**SPECIAL CITY PLANNING COMMISSION MEETING**

Thursday, August 15, 2013

**STAFF REPORT TO CITY PLANNING COMMISSION**  
Major Preliminary Plat

**STAFF REPORT TO CITY PLANNING COMMISSION**  
Rezoning with a Preliminary Site Development Plan

**PRELIMINARY PLAT**  
 ROGER L. FRENCH ADDITION

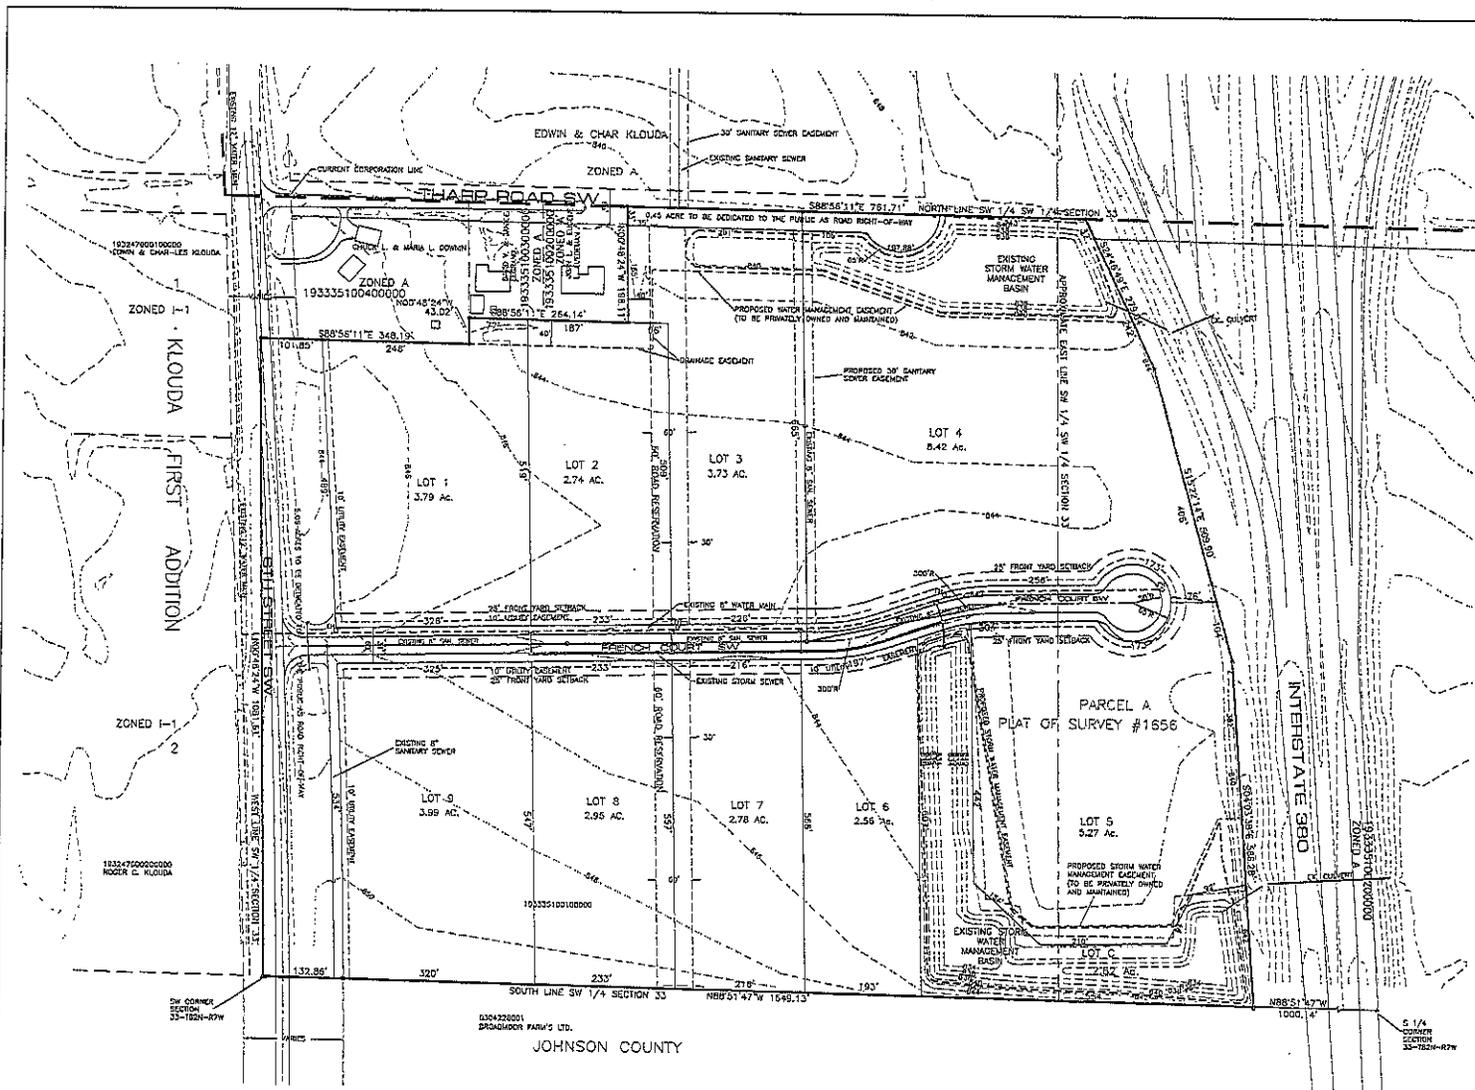
*Staff Comments:* The proposed use and development are consistent with the intent and purposes of the Comprehensive Plan and all City codes and regulations.

1. PRIOR TO THE ISSUANCE OF A CERTIFICATE OF OCCUPANCY, for the lot(s) through which overland conveyance of the 100-year storm event will occur, the property owner shall provide certification by a civil engineer licensed in the State of Iowa verifying the runoff from the 100-year storm event can be conveyed through the site without damage to building structures, OR, the property owner shall provide a certification by a Civil Engineer or Land Surveyor licensed in the State of Iowa the drainage way has been constructed in accordance with drainage plans approved by the City.

2. AS PART OF FINAL PLAT APPROVAL BY CITY COUNCIL, the property owner shall submit to the City a signed Agreement for Private Storm Water Detention. The City Public Works Department shall provide a copy of the Agreement form upon request by the property owner.

6. That, AS PART OF FINAL PLAT APPROVAL BY CITY COUNCIL, access control shall be established and shown on the final plat such that direct access to 6th Street SW is prohibited.

7. That, AS PART OF THE FIRST PLAT APPROVAL BY THE CITY FOR THIS SITE, the property owner shall be responsible to dedicate to the public for street right-of-way purposes: a minimum 100' half width right-of-way for 6th Street SW adjoining this site; the entire French Court SW right-of-way; a minimum 33' wide half width right-of-way for Tharp Road SW adjoining this site; at the easterly end of Tharp Road SW a half width cul-de-sac right-of-way suitable for commercial/industrial zoning. The property owner shall dedicate applicable sanitary sewer easements and utility easements including a sanitary sewer easement for facilities located north of Tharp Road SW and providing service to this site.

**REZONING SITE DEVELOPMENT PLAN  
FOR  
THE COMMONS ON ELLIS BOULEVARD  
IN THE CITY OF CEDAR RAPIDS, LINN COUNTY, IOWA**

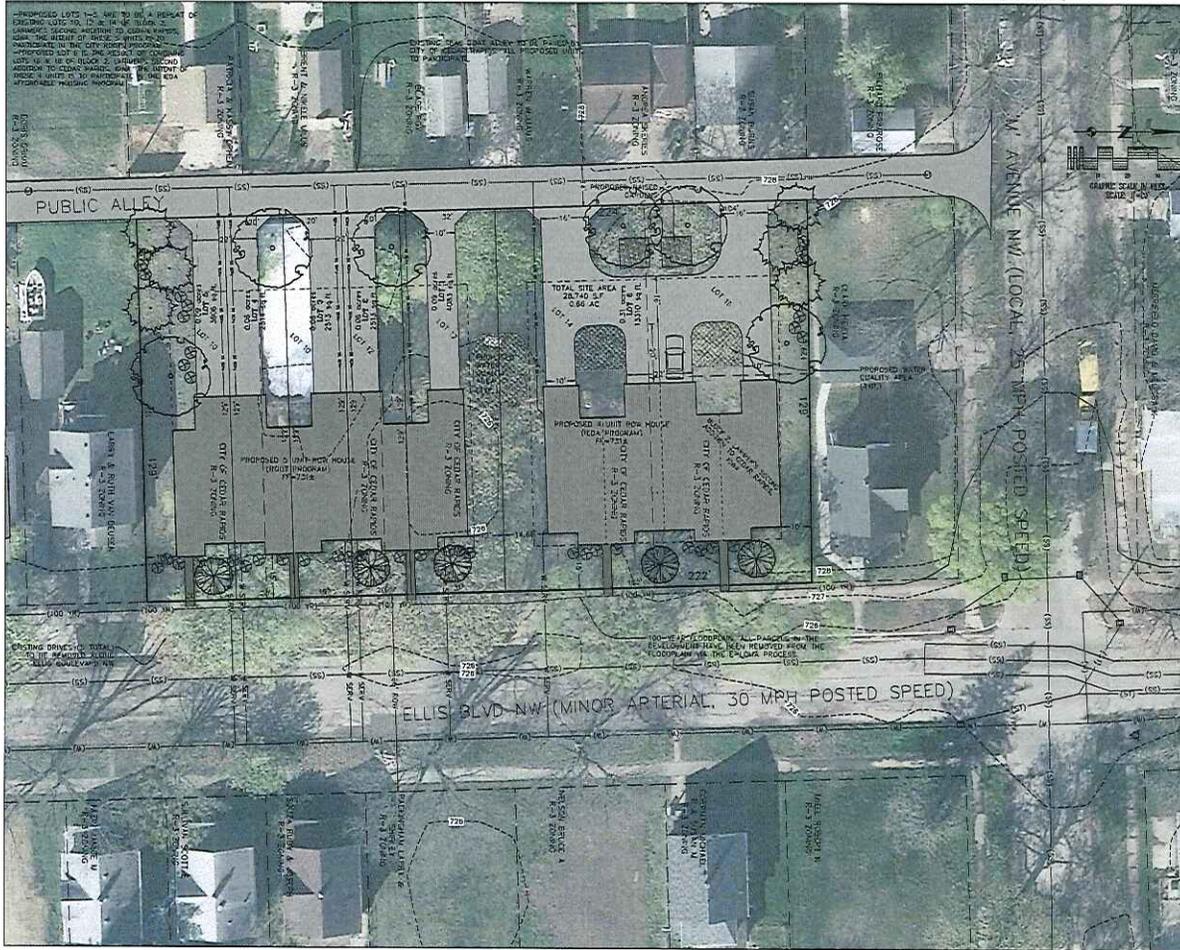
*Staff Comments:* This amendment is not to correct a technical mistake on the existing Zoning Map.

*Staff Comments:* The Framework Plan Map in the City of Cedar Rapids Framework Plan for Reinvestment and Revitalization designates the property for medium intensity uses so the requested zone change is in accord with the Frame Work Map and the goals and objective of said Plan. This proposed multi-family house development provides affordable work force housing in the flood inundated area, which was recently established as the Ellis Overlay District.

*Staff Comments:* The property is currently undeveloped, but is property in an area the City desires to see developed with a mix of uses. The proposed use will generate moderate traffic. The surrounding area is primarily developed as single-family residential, but the proposed development will provide a density similar to the rest of the neighborhood and will be consistent with what was on the property pre-flood. Also the two-story structures will be designed to be compatible with the surrounding area with regard to architectural design and building height. Staff has not received objections for this application.

*Staff Comments:* As noted in Finding 3, the proposed structures will be designed to fit in architecturally with the surrounding residential housing in the neighborhood. Also the Ellis Overlay Technical Review Committee has reviewed the design and has recommended approval.

4. That the subject property shall be platted per State and City platting regulations.
5. That lots 14 & 16 of Block 2, Larimer's 2nd Addition are to be combined so as to constitute a single zoning lot and tax parcel.

6. That evidence of acceptable shared access easement agreements for the proposed 5 unit row house is required.
7. That review of the proposal will be required by the Ellis Overlay District Design Review Technical Advisory Committee.

8. That landscaping and buffering/screening shall be provided per the Zoning Ordinance,

Subsection 32.05.030.A. or the applicant shall request City Council waive this requirement.

PRELIMINARY SITE DEVELOPMENT PLAN  
FOR  
**9TH AVENUE BRICKSTONE**  
IN THE CITY OF CEDAR RAPIDS, LINN COUNTY, IOWA

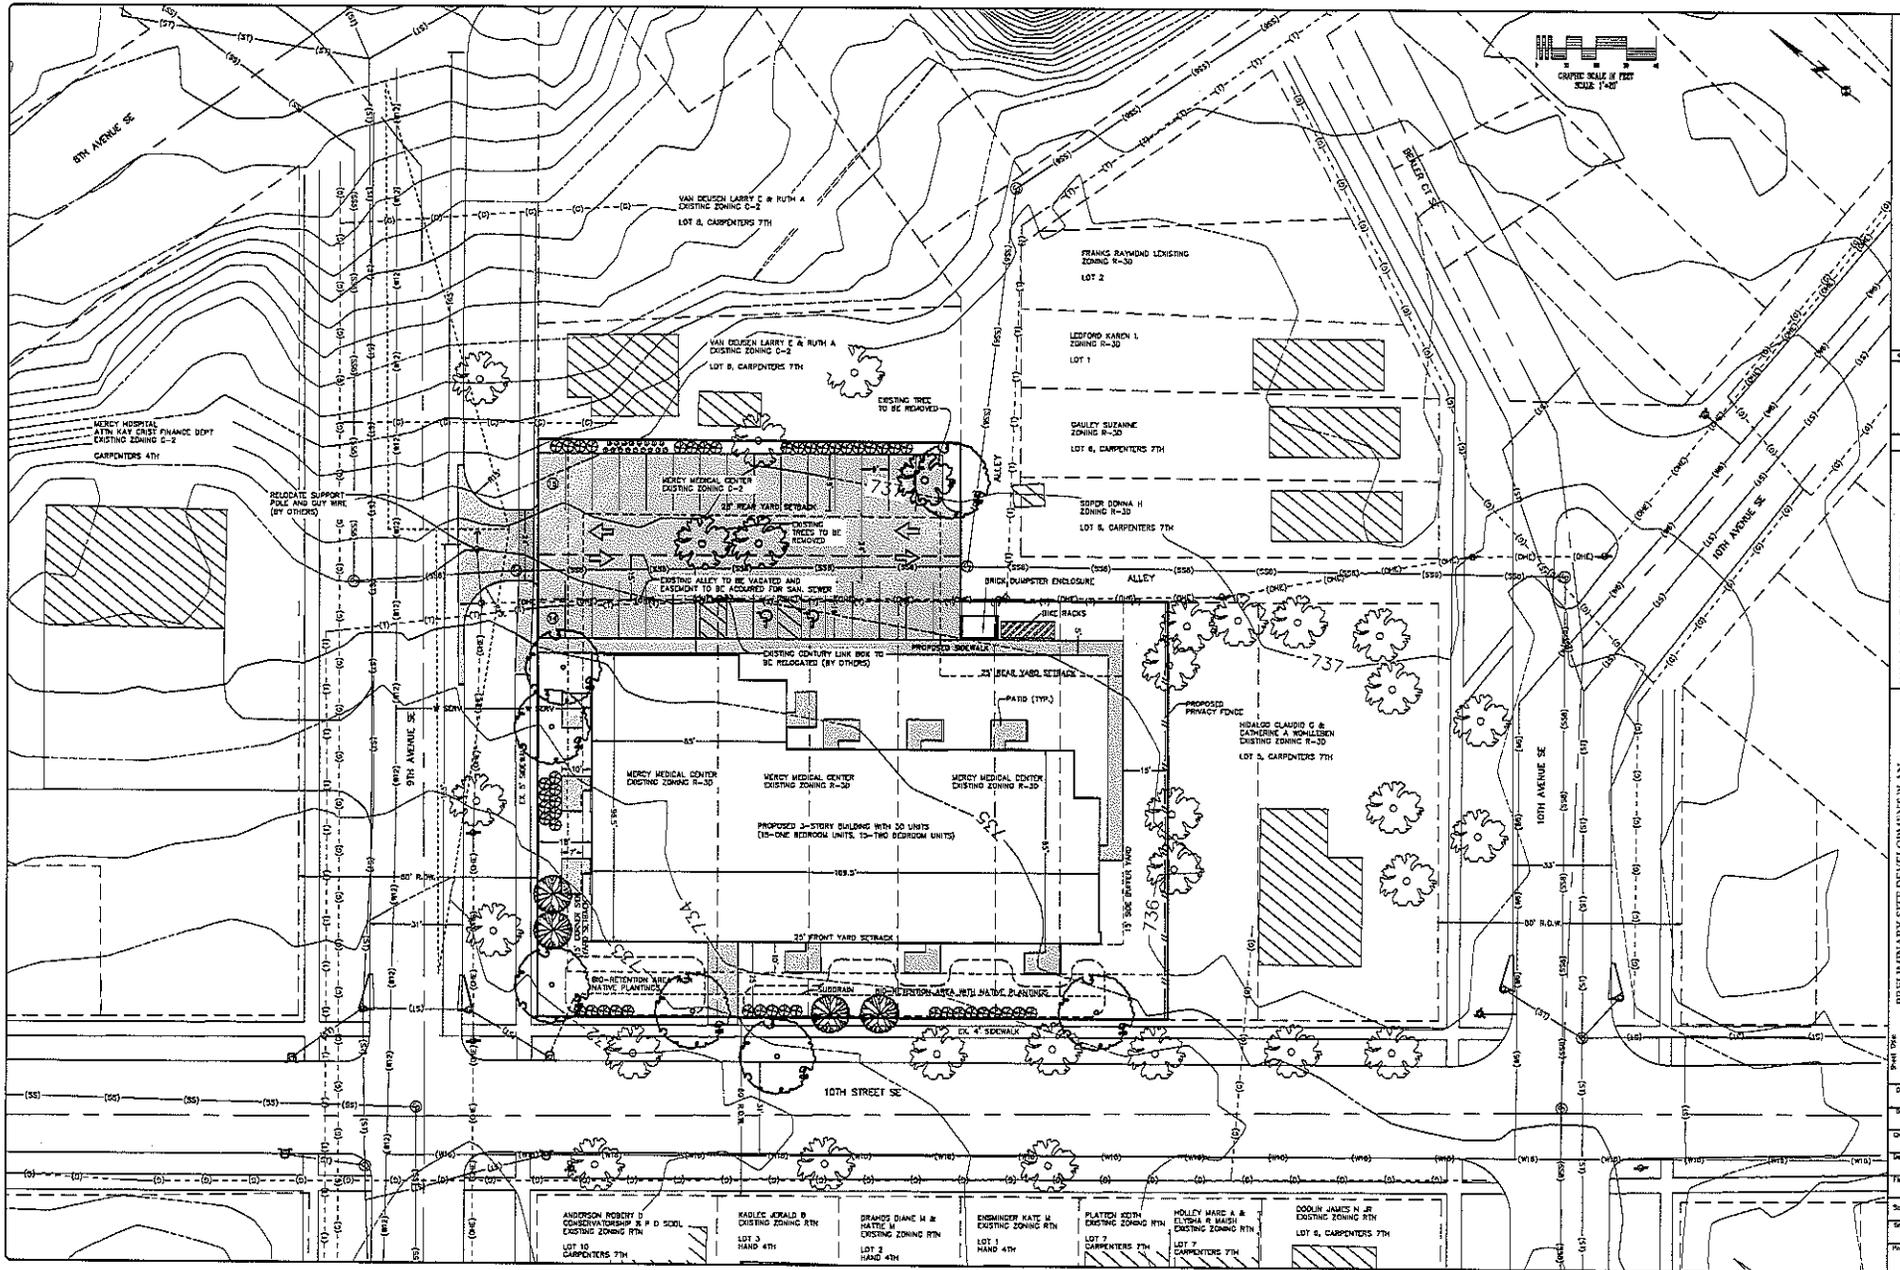
*Staff Comments:* The property is currently undeveloped, but was previously used for temporary trailers for Mercy Hospital while they repaired flood damage to the Hospital. The proposed use will generate moderate traffic. The property is surrounded by single-family homes on the west, east and south side. The north side of 9<sup>th</sup> Avenue SE is developed with medical and service related uses. There is also commercial and service related use along the Mt. Vernon Road SE corridor to the northeast. Staff has not received any objections for this application. The applicant held a neighborhood meeting and no one in the neighborhood voiced issues or concerns.

*Staff Comments:* Although the proposed building is 3-stories, it should not be out of context with the surrounding housing units, which are typically 2-1/2 stories. It should also be noted the Oakhill-Jackson Neighborhood Association has voiced concerns in the past objecting to multi-tenant apartment buildings proposed in the Neighborhood. The applicant met with members of the Association and they had no issues or concerns since this project is on the edge of the Neighborhood boundary and close to Mercy Hospital and the Medical District.

4. That said lots are to be combined so as to constitute a single zoning lot and tax parcel.
5. That required off-street parking shall be provided per provisions of the Zoning Ordinance or a variance be obtained.

6. That an open deck including steps may extend no more than 10 feet into the required front yard or a variance must be obtained.
7. That the parking spaces shall be screened where adjoining the public street or a variance must be obtained.

8. That effective screening shall be provided and maintained so as to screen more than 4 open parking spaces and the drive thereto where adjacent to a residential use per provisions of the Zoning Ordinance or a variance be obtained.

9. That lighting fixtures shall be shielded in a manner that shall not direct illumination on adjacent residential properties, or on any public right-of-way.

10. The enclosure for the dumpster will need be a full screen enclosure including the gates and preferably designed using the same building material as the principal building as per Subsection 32.05.030.A.7. of the Zoning Ordinance.

# PRELIMINARY SITE DEVELOPMENT PLAN

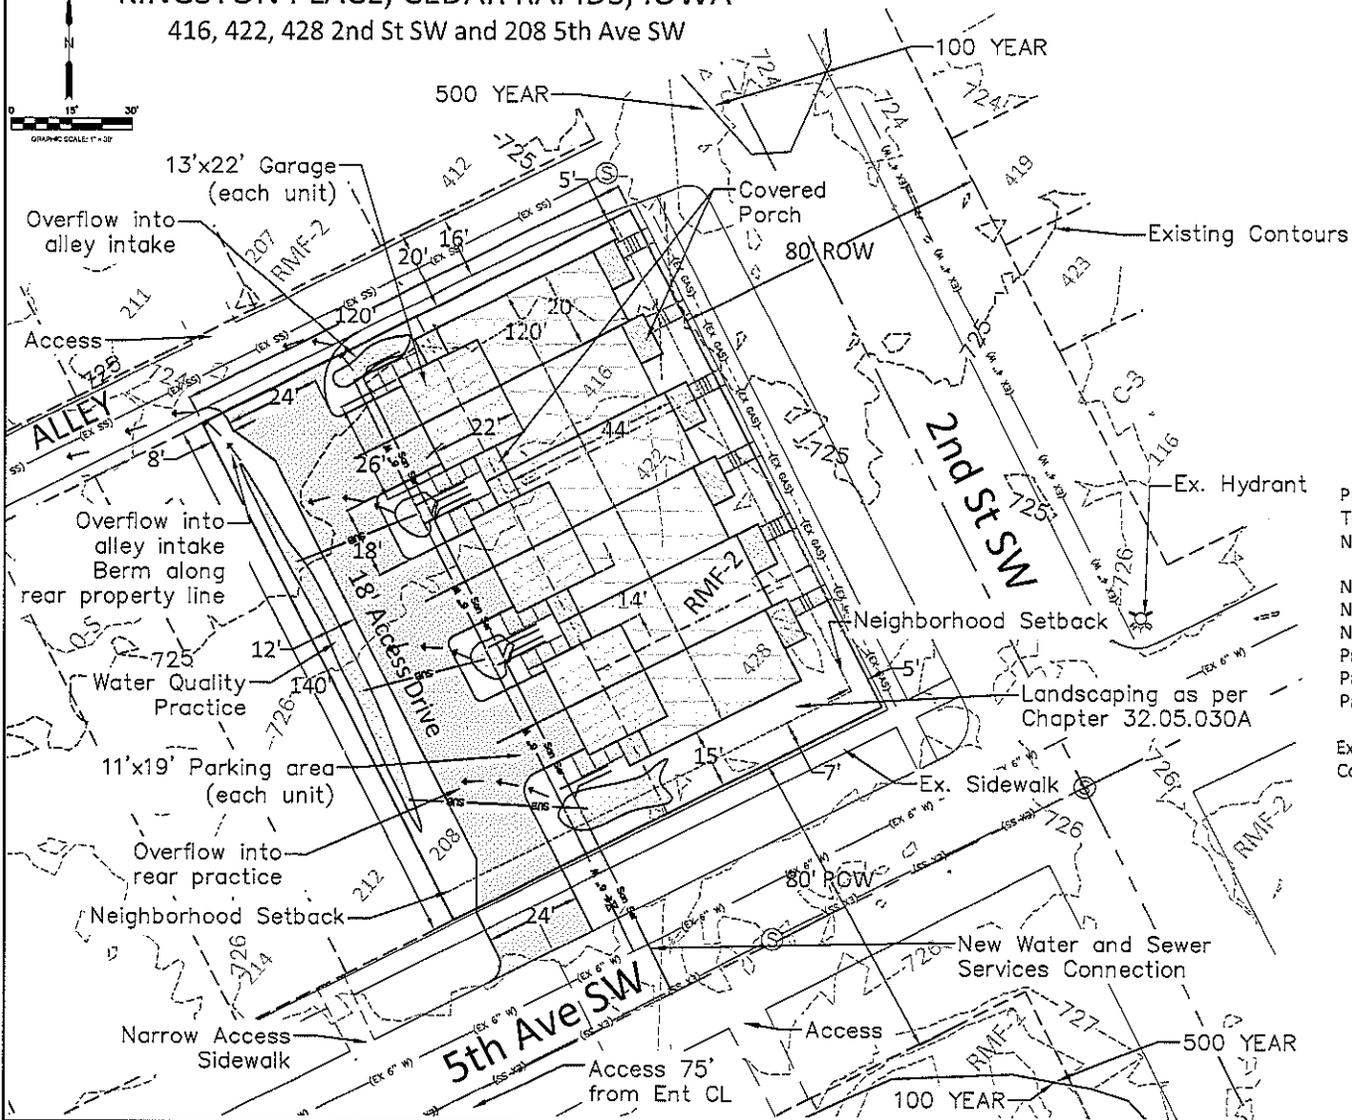
*Staff comments:* The finding does not apply since there was no previous approved site plan for this property.

*Staff comments:* The site development plan conforms to all applicable requirements of the City's Zoning Ordinance and other applicable codes and regulations provided the conditions proposed by City staff are complied with.

1. PRIOR TO THE ISSUANCE OF A FINAL CERTIFICATE OF OCCUPANCY, the property owner shall be responsible for removal and replacement of City sidewalk adjoining this site, damaged as a result of construction activities on this site or not meeting ADA standards. Said removal and replacement areas shall be determined by the City Public Works Department, shall be completed by the property owner, and approved by the City.

2. PRIOR TO THE ISSUANCE OF A FINAL CERTIFICATE OF OCCUPANCY, the property owner shall be responsible to submit to the City a signed Agreement for Private Storm Water Quality improvements on this site. The City Public Works Department shall provide a copy of the Agreement form upon request by the property owner.
